Product Change Notice (PCN)

Subject: Bond wire material and factory change for RL78/F12 32pin QFN package products

Publication Date: 3/21/2025

■Part number specification

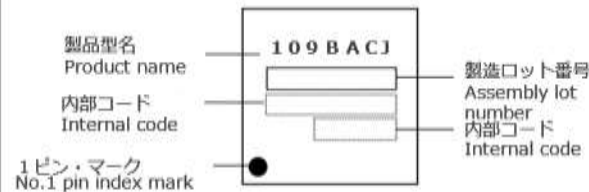
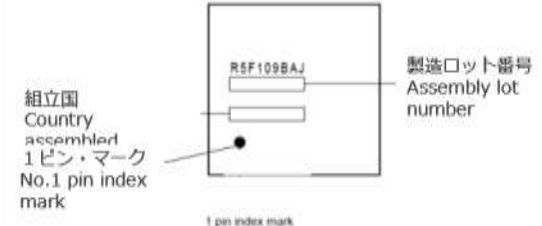
The code "C" representing Cu wire is inserted in part number of Cu wire products for distinguishing from Au wire products wire products and Au wire products have different suffixes. See below for table.

Body	Suffix(Packing type)		
			Tray (Full carton)	Tray	T/R
Current	Au wire	R5F1xxxx	G0	U0	W0
Alternative	Cu wire	R5F1xxxx C	10	30	50
Points to changes		9桁目に"C"追加 "C" is added to the 9th digit.	末尾から2桁目が変更(末尾"Q","G"の時は末尾から3桁目が変更) The second digit from the end of the Suffix change. (If "Q" and "G" at the end of Suffix, the third digit from the end change.)

Ex) Cu wire: R5F109BACJNA#10Q

Au wire: R5F109BAJNA#G0Q

Marking Specification

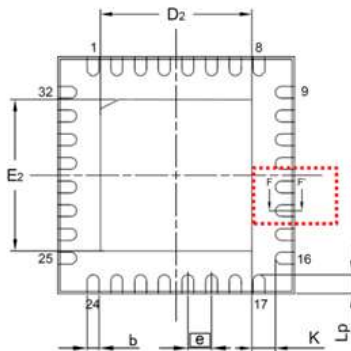
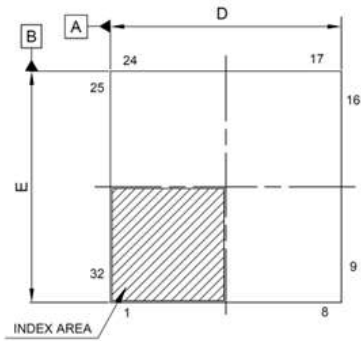
Marking specifications will be changed as follows.

Cu wire Alternate	Au wire Current
<p>RL78/F12 R5F109BACJNA#10</p>  <p>製品型名 Product name</p> <p>内部コード Internal code</p> <p>1ピン・マーク No.1 pin index mark</p> <p>製造ロット番号 Assembly lot number</p> <p>内部コード Internal code</p>	<p>RL78/F12 R5F109BAJNA#G0</p>  <p>組立国 Country assembled</p> <p>1ピン・マーク No.1 pin index mark</p> <p>製造ロット番号 Assembly lot number</p>

Package Drawing (Renesas Semiconductor KL Sdn.Bhd.)

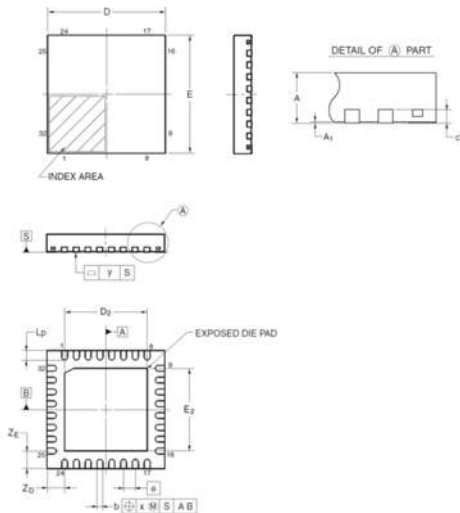
■Package Outline (1/2)

HWQFN with Half-cut Wettable flank

Alternate Cu wire

Reference Symbol	Dimension in Millimeters		
	Min.	Nom.	Max.
D	4.85	5.00	5.15
E	4.85	5.00	5.15
A	—	—	0.80
A ₁	0.00	—	0.05
b	0.18	0.25	0.30
e	0.50 BSC		
L _p	0.35	0.40	0.45
y	—	—	0.08
c	—	0.20	—
K	0.20	—	—
D ₂	—	3.20	—
E ₂	—	3.20	—

Tray Outline Drawing (Renesas Semiconductor KL Sdn.Bhd.)

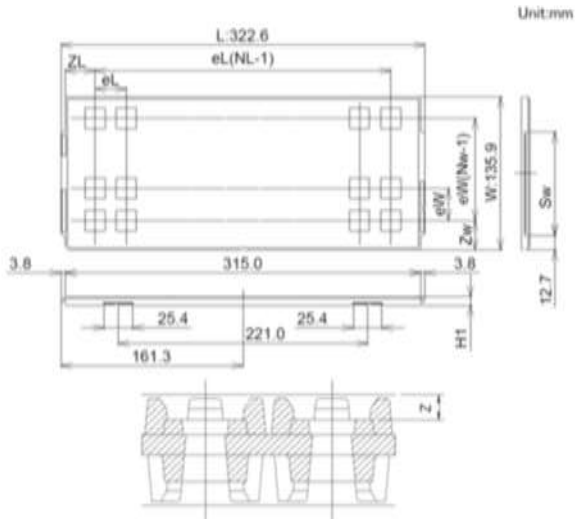
■ Packing change (1/2)

There are no tape & reel changes.

The tray will be changed as follows.

Alternate Cu wire

Tray Code	EAM050501-10	
Position dimension of cells	Z	1.75
	Zw	8.15
	ZL	7.90
	eW	9.20
	eL	8.80
Thickness (mm)	H1	7.62
	Nw	14
Number of cells	NL	35
	Maximum storage pcs IC/Tray	
		490
Maximum storage pcs IC/Inner box		3920
Material		Carbon PPE
Heat resistant temperature		135°C MAX
JEDEC or Custom		JEDEC
Surface resistance		Less than $1 \times 10^{11} \Omega/\square$

Tray Outline Drawing (Amkor Technology Japan, Inc. Kumamoto Plant)

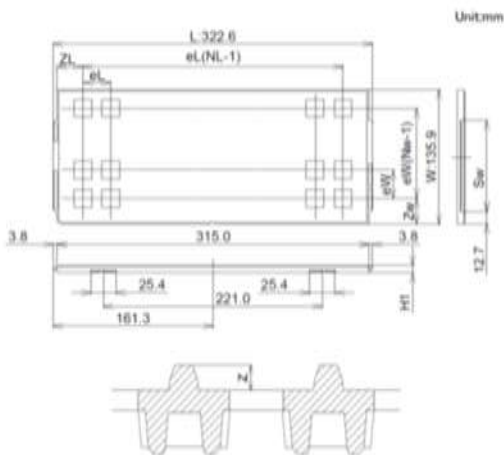
Current Au wire

Tray Code	Rev.B EAM050503-10	
Position dimension of cells	Z	1.50
	Zw	8.15
	ZL	7.90
	eW	9.20
	eL	8.80
Thickness (mm)	H1	7.62
	Nw	14
Number of cells	NL	35
	Maximum storage pcs IC/Tray	
		490
Maximum storage pcs IC/Inner box		3920
Material		Carbon PPE
Heat resistant temperature		135°C MAX
JEDEC or Custom		JEDEC
Surface resistance		Less than $1 \times 10^{11} \Omega/\square$
